Form 3160-5
(June 2019)

SUNDRY NOTICES AND REPORTS ON WELLS
Do not use this form for proposals to drill or to re-enter an abandoned well. Use Form 3160-3 (APD) for such proposals.

Jupiter 29 Fed Com 104H API #: 30-025-52436

EOG respectfully requests an amendment to our approved APD for this well to reflect the following changes:

Revised Wellbore A:

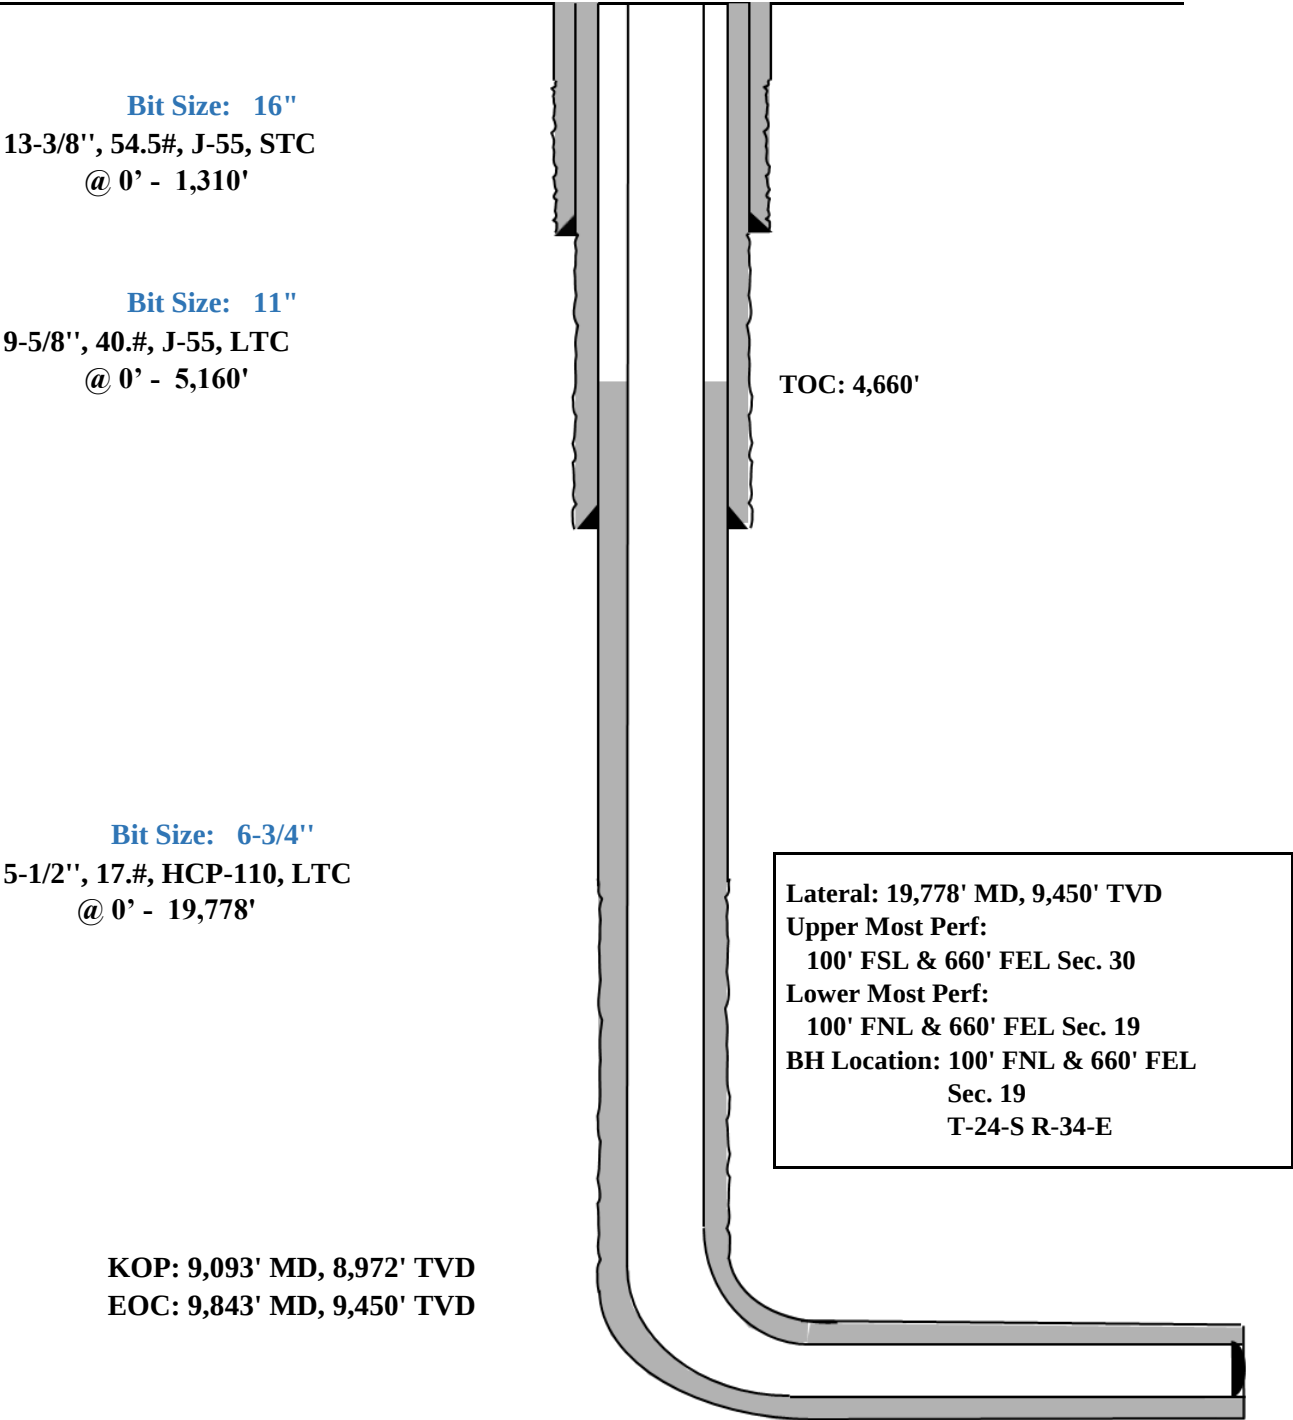
Change BHL from T-24-S, R-34-E, Sec 19, 100' FNL, 995' FEL, Lea Co., NM,
to T-24-S, R-34-E, Sec 19, 100' FNL, 660' FEL, Lea Co., N.M.

BHL: 100' FNL & 660' FEL, Section 19, T-24-S, R-34-E, Lea Co., N.M.
